TOLEDO - LUCAS COUNTY PLAN COMMISSIONS

SUBJECT: Amendment to Planned Unit Development, originally granted by Ord. 150-25 & Ord. 439-25, for new library at 3027 W. Alexis Road.

REF: PUD26-0007

APPLICATION FOR AMENDMENT TO A PLANNED UNIT DEVELOPMENT

Proposed Site Plan:

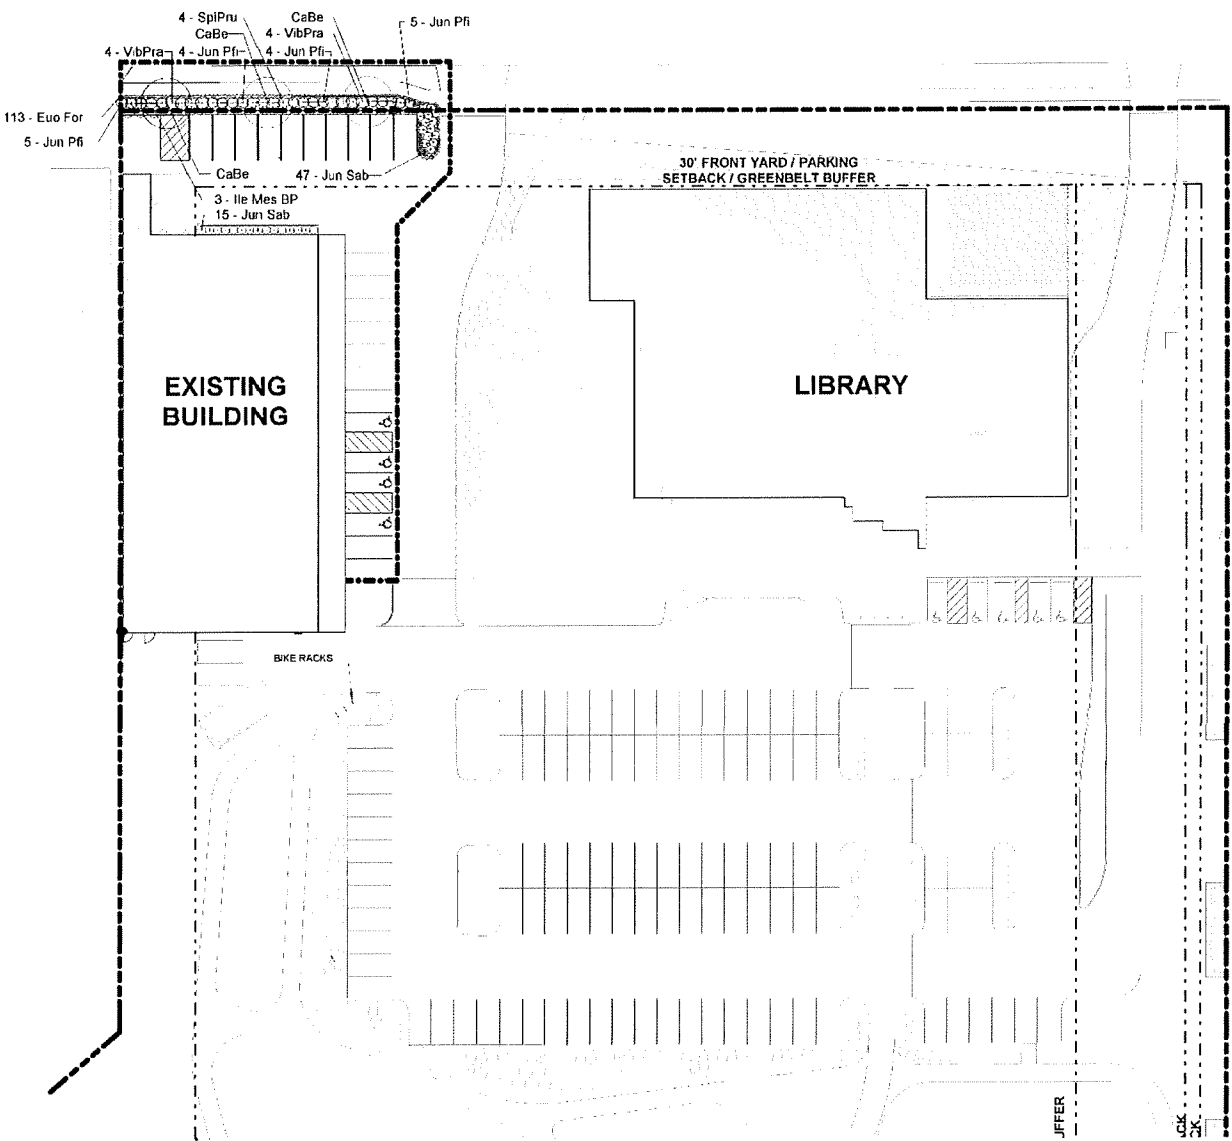
- (a) *Bicycle Parking (TMC§1107.0900)*. Seventeen (17) bicycle parking slots are required. Bicycle parking spaces have been provided throughout the site as previously reviewed. To ensure that the required bicycle parking slots are provided and are located within close proximity to all of the different uses, the overall site plan shall be revised to show the required bicycle parking slots and locations to ensure compliance with this requirement. – Not acceptable
- (b) *Wheel Stops (TMC§1107.1907)*. Wheel stops are required for all parking spaces along the perimeter of the parking lot as the lot extends to a property line, sidewalk, and/or planting strip. Wheel stops are required for the parking spaces along Alexis Road; however, none are depicted on the site plan. – Not acceptable

- (a) *Frontage Greenbelt (TMC§1108.0202)*. A minimum thirty-foot (30') wide frontage greenbelt along Alexis Road is required. The frontage greenbelt must contain four (4) trees and a solid evergreen hedge. The existing parking is situated along the property line; therefore, the required buffer can't be provided if the parking remains. A ±8.0 foot landscape buffer with three (3) trees and a variety of shrubs is depicted on the landscape plan in the right-of-way immediately north of the parking spaces. – Not acceptable. A waiver is required for the greenbelt requirement. In addition, one (1) additional tree shall be provided and the proposed spirea shrub replaced with an evergreen shrub.

- (c) *Dumpster/Trash Receptacle Screening (TMC§1108.0203(D))*. Dumpsters are not permitted in the required setback or landscape buffers and shall be located as far away from residential areas as possible. There are two (2) existing dumpsters located in the northwest corner of the property that are not screened. The required screening is proposed; however, the dumpsters are situated within the required thirty-foot (30') wide frontage greenbelt. – Not acceptable. A waiver is required.

- (a) *Connecting Walkways (TMC§1109.0204(A))*. At least one (1) main entrance shall face and open directly onto a five-foot (5') wide connecting sidewalk to the street sidewalk and must be distinguished from driving surfaces. Even though the building is existing and the main entrance does not face Alexis Road, a connecting walkway from the entrance to the sidewalk along the street shall be provided. – Not acceptable

9. Bicycle Parking is required per TMC§1107.0900. Seventeen (17) bicycle parking slots are required. Bicycle parking spaces have been provided throughout the site as previously reviewed. To ensure that the required bicycle parking slots are provided and are located within close proximity to all of the different uses, the overall site plan shall be revised to show the required bicycle parking slots and locations to ensure compliance with this requirement. **Not acceptable as submitted.**

11. Wheel stops are required for all parking spaces along the perimeter of the parking lot as the lot extends to a property line, sidewalk, and/or planting strip per TMC§1107.1907. Wheel stops are required for the parking spaces along Alexis Road; however, none are depicted on the site plan. **Not acceptable as submitted.**

12. Dumpsters are not permitted in the required setback or landscape buffers and shall be located as far away from residential areas as possible per TMC§1108.0203(D). Two (2) dumpsters are proposed to be situated within the required thirty-foot (30') wide frontage greenbelt in the northwest corner of the property **Not acceptable as depicted. A waiver shall be secured or the dumpsters relocated to meet this requirement.**

- a. Per TMC§1108.0202, a minimum thirty-foot (30') wide frontage greenbelt along Alexis Road is required. The frontage greenbelt must contain four (4) trees and a solid evergreen hedge. The existing parking is situated along the property line; therefore, the required buffer can't be provided if the parking remains. A ± 8.0 foot planting bed with three (3) trees and a variety of shrubs is depicted in the right-of-way immediately north of the parking spaces on the landscape plan. **Not acceptable as submitted. A waiver is required or the site plan revised to meet the frontage greenbelt requirement. In addition, one (1) additional tree shall be provided and the proposed spirea shrub replaced with an evergreen shrub.** If the waiver is granted, the applicant shall be responsible for maintaining the landscape buffer and ensuring that it does not encroach in the site distance setback in TMC§1107.2000.

- e. Per TMC§1103.1209(A.3), grade level mechanical equipment shall be screened from adjoining residential parcels and from the right of way(s).
- f. Per TMC§1108.0204(B.6), landscaped areas may not contain bare soil, aggregated stone, or decorative rock. Any ground area must be covered with hardwood mulch, grass, or other vegetative ground coverage. The proposed rock mulch is not permitted.

14. Connecting walkways and pedestrian connections are required per TMC§1109.0204(A). At least one (1) main entrance shall face and open directly onto a five-foot (5') wide connecting walkway to the street sidewalk. **Not acceptable as depicted.** A five-foot (5') wide connecting walkway shall be provided from the main entrance to the existing sidewalk on Alexis Road. The walkways shall be distinguished from driving surfaces where it crosses parking aisles or driveways.
